Minor Site Plan and Shoreland Zone Permit Approval with Conditions June 12, 2019 – Revised to Add Fire Department Condition

Minor Site Plan and Shoreland Zone Permit
Sparhawk Mill Restaurant and Parking Lot with Stormwater Management
81 Bridge Street, Map 33 Lot 66
Sparhawk LLC, Applicant

Relocate Snow Storage Away from River, Above Vegetated Buffer Area

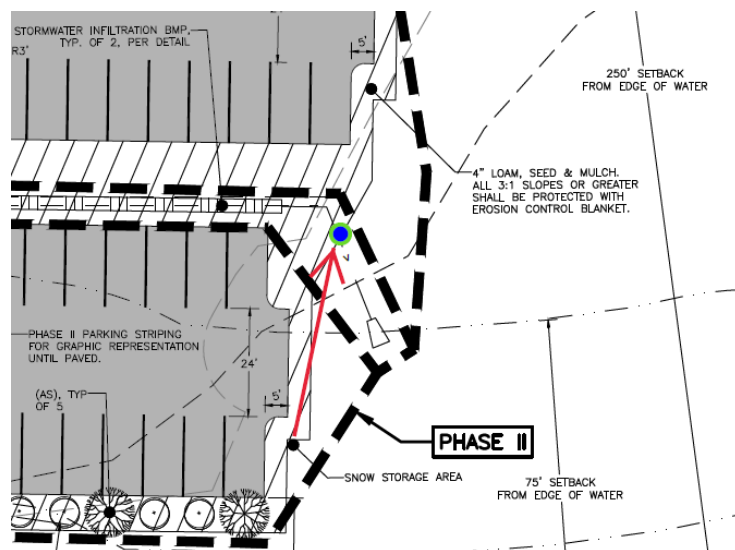
The Town Engineer has reviewed the storm water management plan and finds it acceptable. A detail of the rip-rap apron outlet protection is missing from the detail sheet, C-31, and shall be provided for Town Engineer review and approval. The Public Works Director notes that Snow storage areas should be identified on the plan and positioned where there are vegetated buffers downstream of the melt water. To this end, the southerly snow storage area shown on Sheet C-10 shall be relocated approximately 45' to the north, above the rip-rap apron outlet. Pile locations should also be positioned where melt water will not run across roads or parking lots, thus requiring additional salt/sand applications. Sediment and waste debris from these locations should be cleaned up at the end of the season as part of a maintenance plan.

Relocate Snow Storage Away from River, Above Vegetated Buffer Area

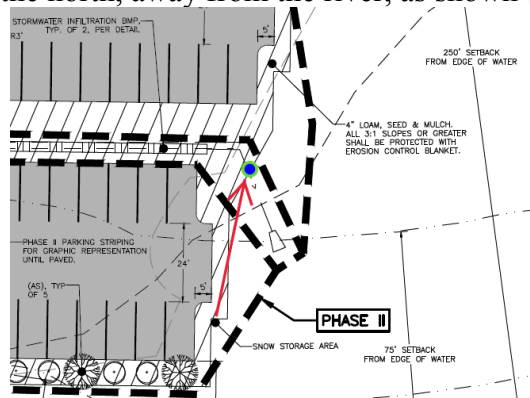
The project is in conformance with the land use standards of the SOD, provided that the grading and relocation of the lower (southeasterly) gravel parking area shall be adjusted as shown on the site plan in Phase I, and the associated landscape plantings be included in Phase 1. The existing gravel parking area violates the 25' river setback. The proposed plan rectifies that situation.

1. A planting schedule shall be submitted showing species, quantity, and size of all proposed plant material, for Planning Director review and approval.
2. The planting along the parking area identified as a potential Phase II shall be provided in Phase I and included in the performance guarantee for Phase I.
3. The five new lighting fixtures shall be placed on timers and shall be turned off or reduced to a maximum of .2 footcandles within one hour after closing.
4. A detail of the rip-rap apron outlet protection is missing from the detail sheet, C-31, and shall be provided for Town Engineer review and approval.
5. Snow storage areas shall be positioned where there are vegetated buffers downstream of the melt water. The southerly snow storage area identified on Sheet C-10 shall be relocated approximately 45' to the north, away from the river, as shown on the image below.
